ADDENDUM NO. 4

PROJECT TITLE: Law Enforcement Training Academy Barracks
Black River Technical College
Pocahontas, Arkansas

COMMISSION NUMBER: 2405

DATE OF ISSUE: September 19, 2024

enlarged second floor plan

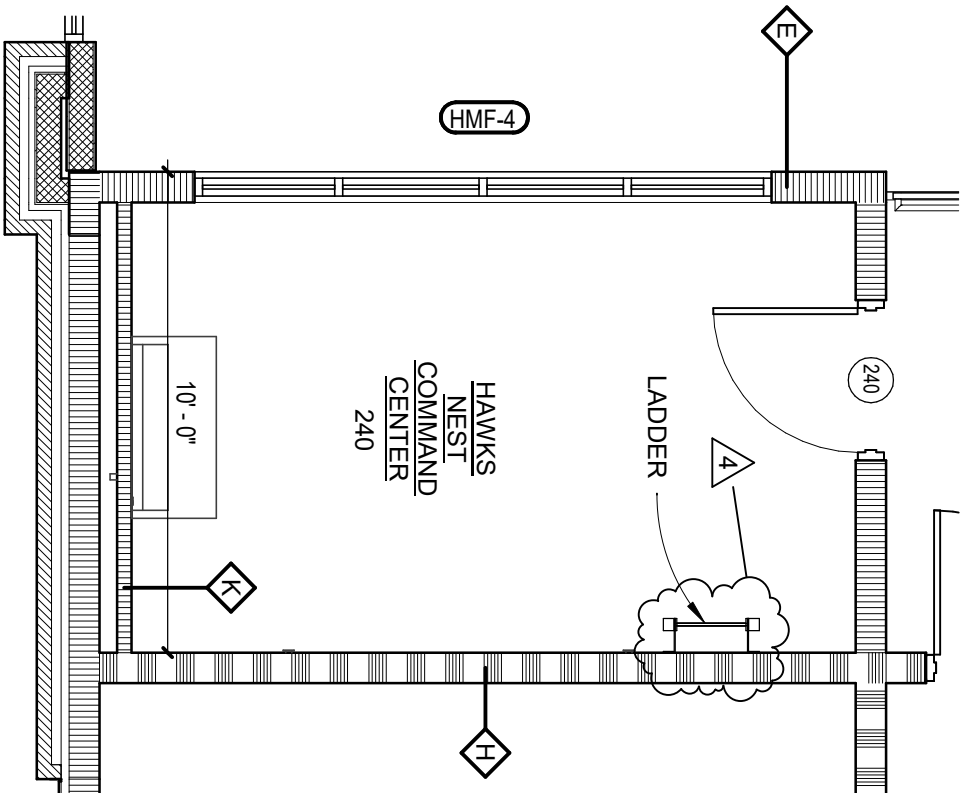
5. Drawings: Refer to Sheet A101

- A. Add Enlarged Second Floor Plan detail and Enlarged Clerestory Plan detail. Pages 10 – 11 of this addendum.

A200

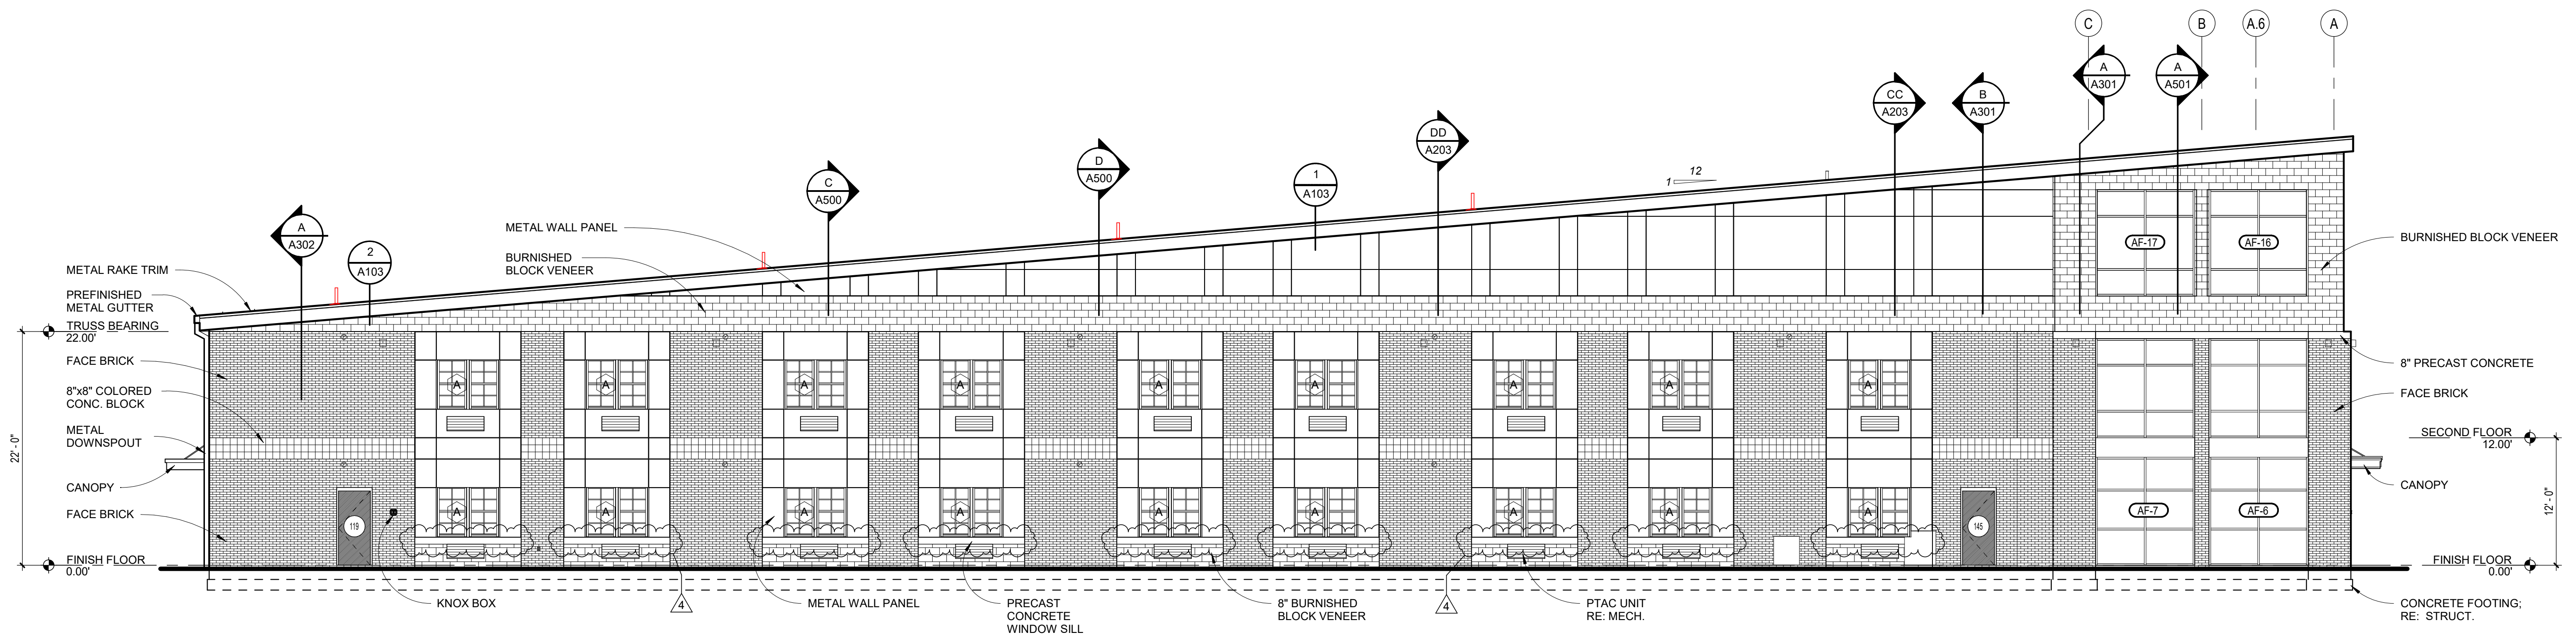
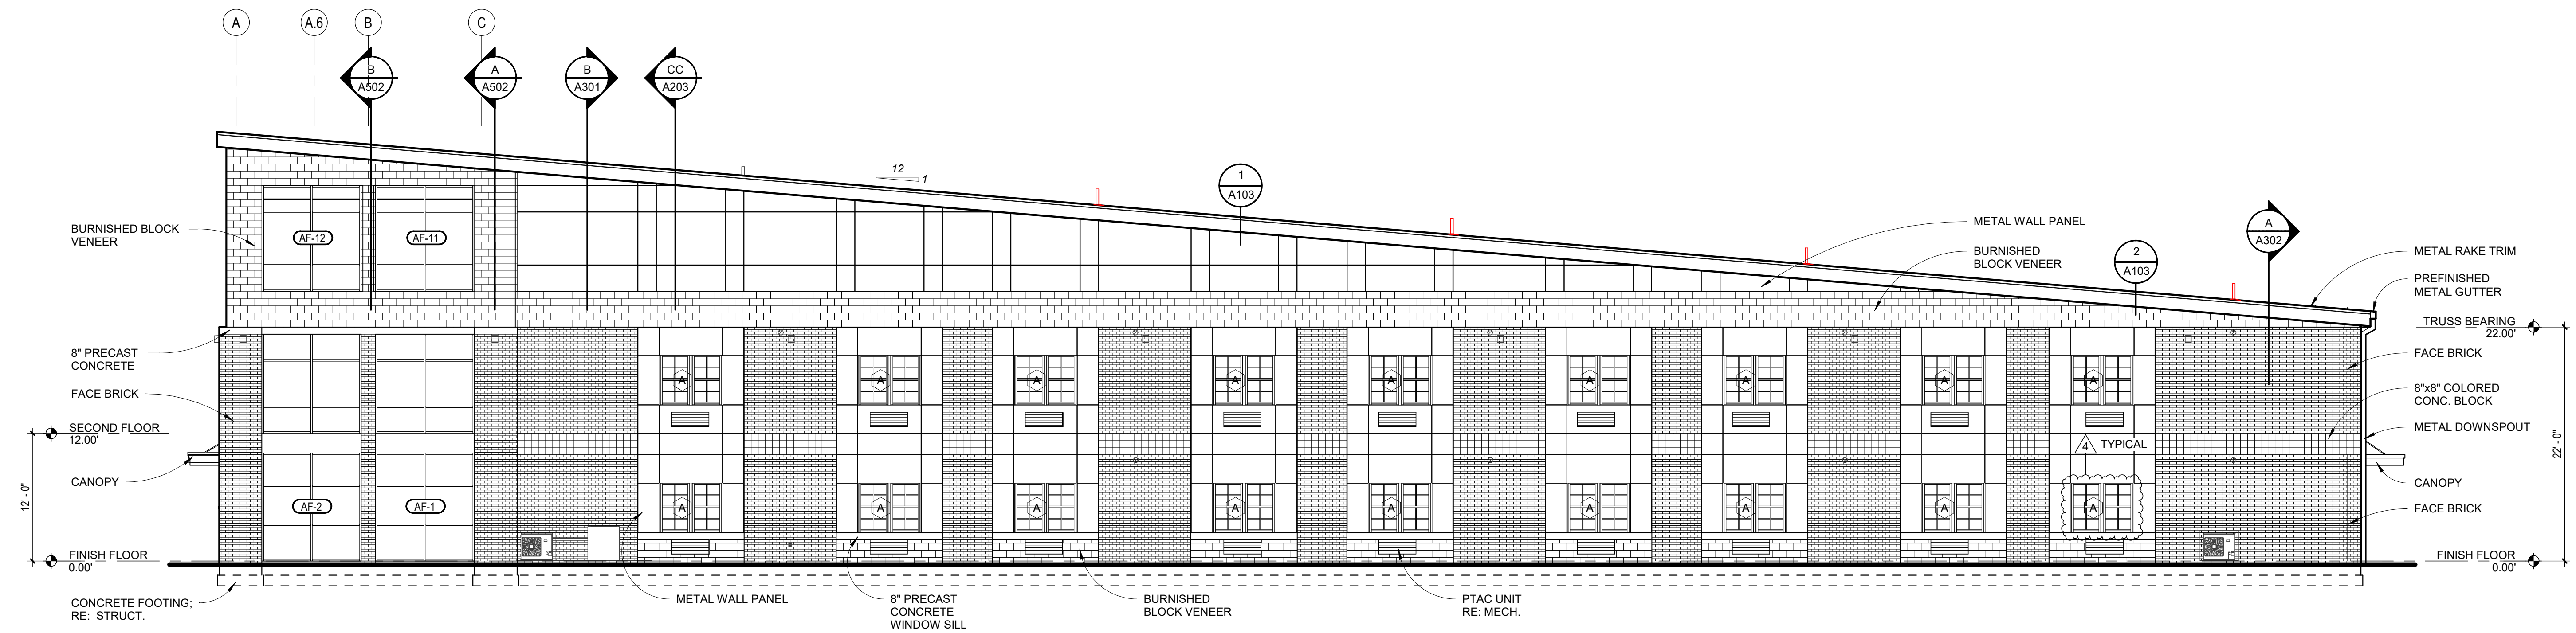
6. Drawings: Sheet A200

- A. Delete in its entirety and replace with page 12 of this addendum.
